# UNITED STATES PATENT AND TRADEMARK OFFICE

APPLICATION NO.	FILING DATE	FIRST NAMED INVENTOR	ATTORNEY DOCKET NO.	CONFIRMATION NO.
10/083,688	02/27/2002	Hiroshi Aoki	Q68731	1569

**Office Action Summary**

## DETAILED ACTION

FIG. 1 PRIOR ART

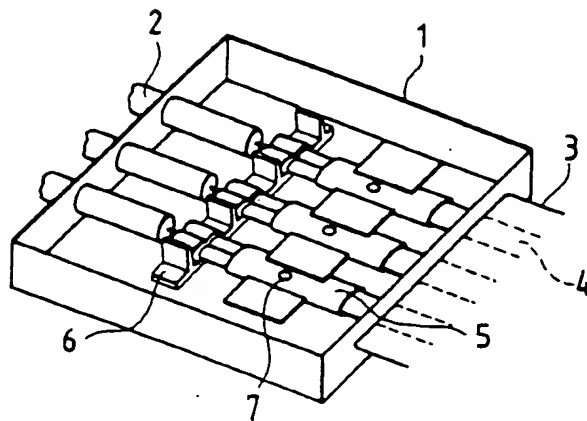
3. Claims 1-2, 6-7, 11-12 and 16-17 rejected under 35 U.S.C. 102(b) as being anticipated by Urushibata et al. (5,057,650, figure 1).

Regarding claims 1 and 11, Urushibata et al., figure 1, discloses a connector for connecting wires (2) to a flat circuit member (3) having a plurality of conductors (4). The connector comprising:

- a plurality of electrical connection terminals, each including a wire connection portion at a rear end portion and a pair of piercing portions (5) to pierce the conductor of the flat circuit member at a front portion; and
- an insulating housing (1) for receiving and holding the plurality of electrical connection terminals at an interval corresponding to an arrangement pitch of the plurality of conductors of the flat circuit member. Each pair of piercing portion pierces the plurality of conductors at one time and is bent back (Column 1, lines 27-30).

FIG. 2

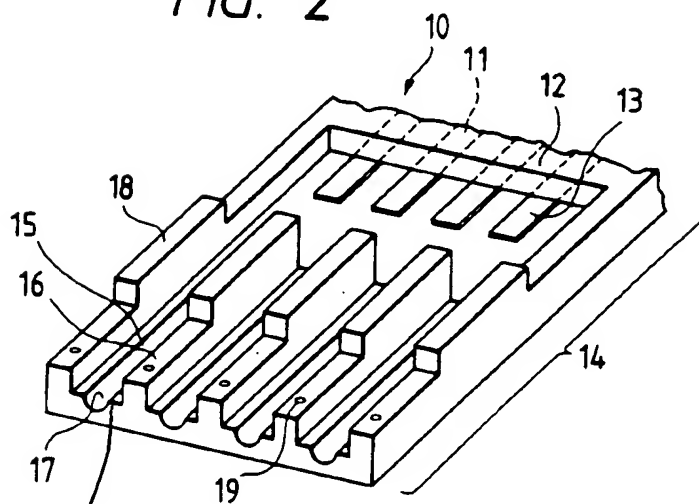
Urushibata et al., figures 2 and 5, discloses a component (10) having a housing (12) with housing grooves (15) and a protective cover (20) which read on the insulating housing includes a housing body with a plurality of terminal receiving grooves and a

Regarding claims 4, 9 and 14, it is noted that Urushibata et al. (figures 2 and 5), disclose each of the plurality of terminal receiving grooves includes a retaining projection (A, attachment) engaged with the electrical connection terminal to position the electrical connection terminal in an axial direction of the electrical connection terminal.
